SUBJECT: Forwards response to NRC 810608 request for addl. info re:
 auxiliary feedwater automatic initiation & flow indication.
 Preliminary diagrams provided.

Re: Turkey Point Units 3 & 4
Docket Nos. 50-250 & 50-251
Auxiliary Feedwater Automatic
Initiation and Flow Indication

REQUEST FOR ADDITIONAL INFORMATION

TURKEY POINT UNITS 3 & 4 AUXILIARY FEEDWATER (AFW)

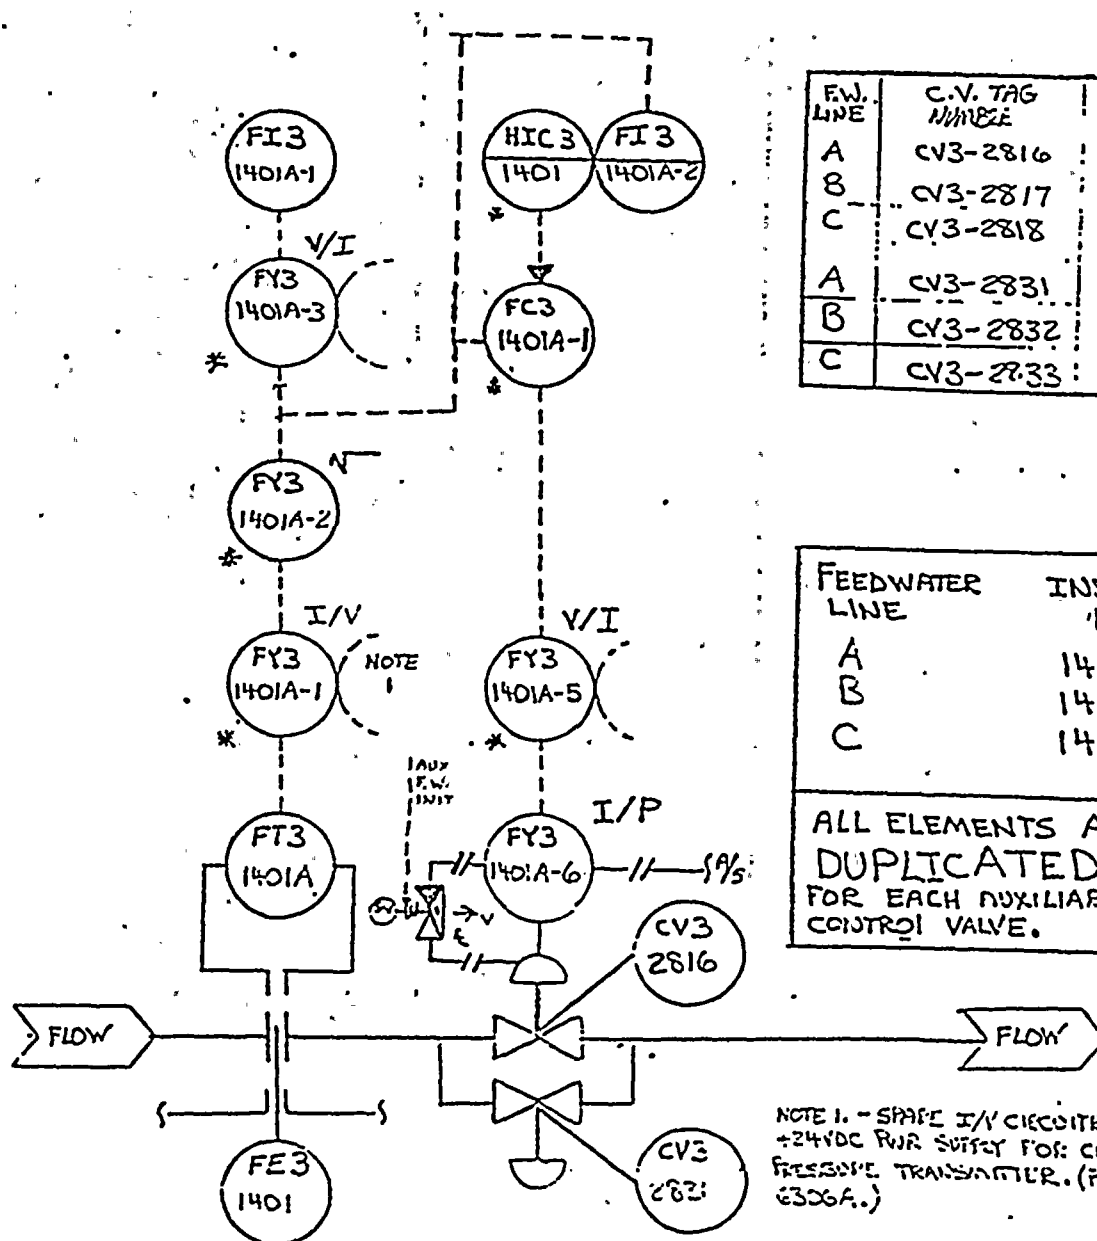
Which of these alternatives has been selected? Provide the new logic and electric schematic diagrams for these valves. If alternative 2 is selected, describe the periodic surveillance planned to provide the operator positive assurance that these valves are in their proper positions.

Alternative 1, with slight modifications, has been selected. For a description of the system, see Enclosure 3 of FPL letter L-81-36, dated February 3, 1981, to Mr. Darrell Eisenhut. Preliminary, new logic and electrical schematic diagrams are attached to this letter, as follows:

5177-109-J305-16, Preliminary Block Diagram
AFW Flow Control
5177-109-J305-17, Preliminary Block Diagram
AFW Flow Control
5177-109-E-05 Sheets 1 and 2, Elementary
Diagram AFW Flow Control and Indication
